July 13, 1984

Docket No. 50-366

The Commission has issued the enclosed Amendment No. 39 to Facility Operating License No. NPF-5 for the Edwin I. Hatch Nuclear Plant, Unit No. 2. The amendment consists of changes to the Technical Specifications (TSs) in response to your requests on the subjects indicated below:

SUBJECT: EDWIN I. HATCH NUCLEAR PLANT, UNIT NO. 2

FUEL TYPE P8DRB284H  
MAXIMUM AVERAGE PLANAR LINEAR HEAT GENERATION  
RATE (MAPLHGR) VERSUS AVERAGE PLANAR EXPOSURE

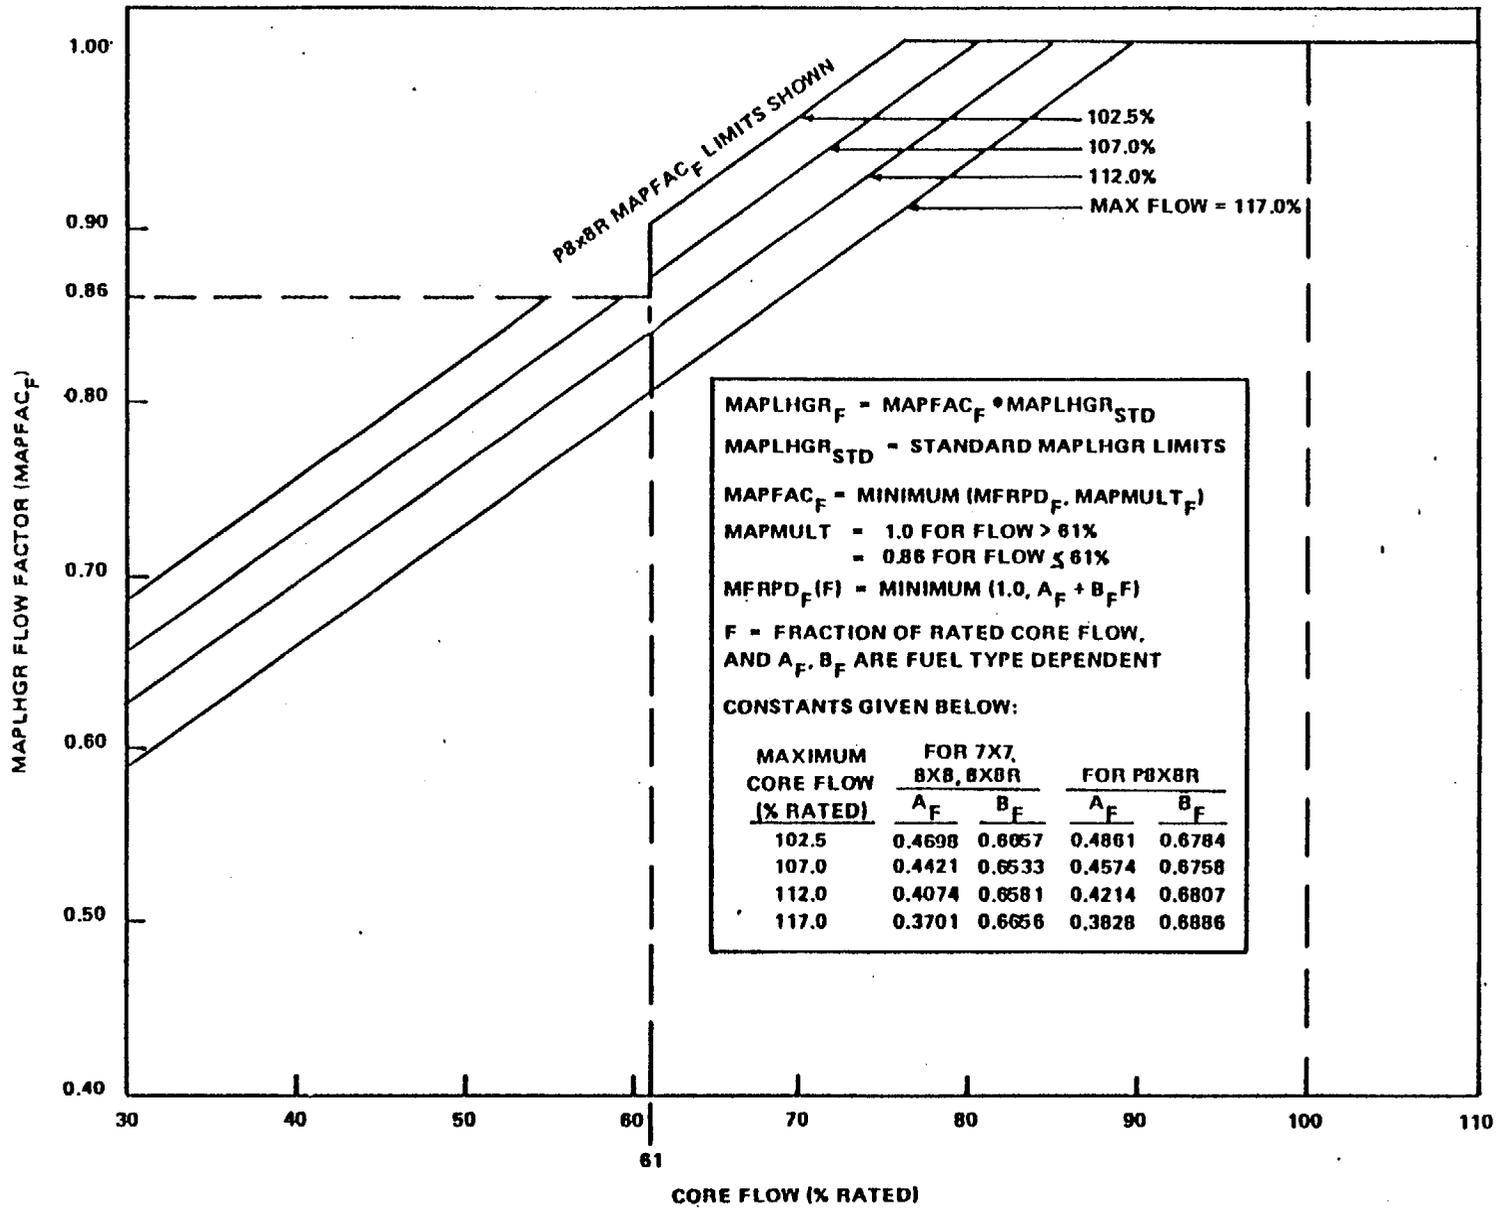
Addition of a new fuel bundle (type P8DRB284H) requires that an additional curve of MAPLHGR as a function of burnup be added to the Technical Specifications. This curve was obtained by methods described in GESTAR II (Reference 2) which have been approved for use in obtaining MAPLHGR values for extended burnup. We conclude that the MAPLHGR values for the new fuel bundle are acceptable.

8X8R FUEL  
FIGURE 3.2.3-1

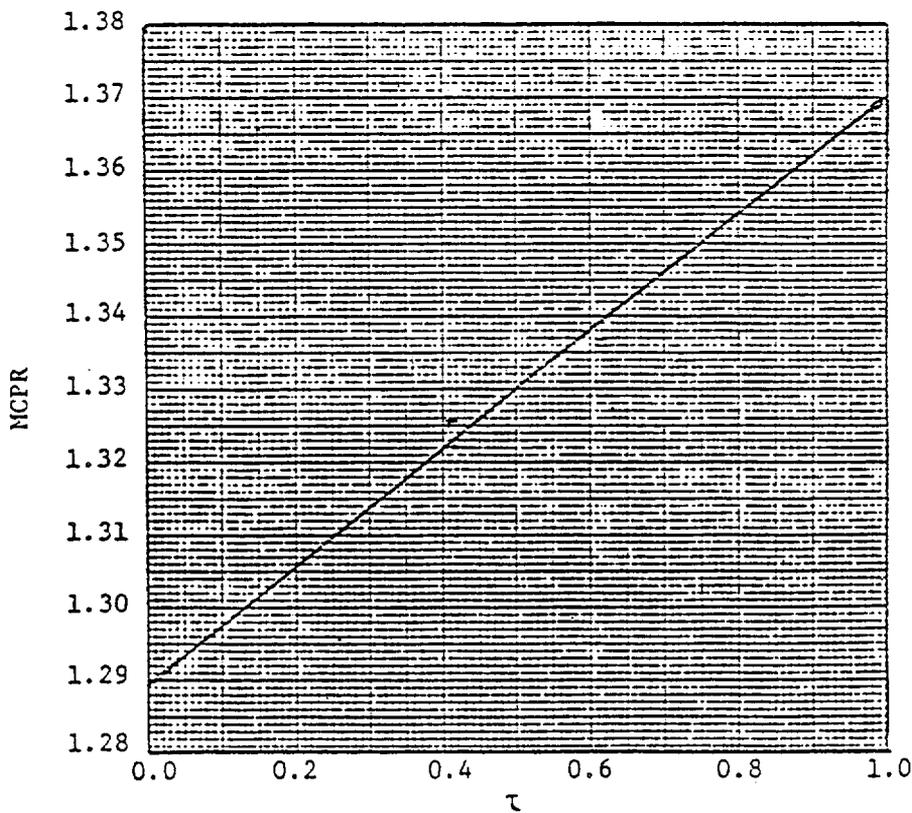
The full power, full flow OLMCPR is being revised to bound required values for Cycle 5 and beyond in order to permit licensing these cycles under 10 CFR 50.59. The proposed revisions would increase the Option B (T = 0) limits to 1.29 and the Option A limits to 1.37. The limits are currently 1.26 and 1.32, respectively, for type 8x8R fuel and 1.27 and 1.35 for P8x8R fuel. These changes are conservative and are therefore acceptable.
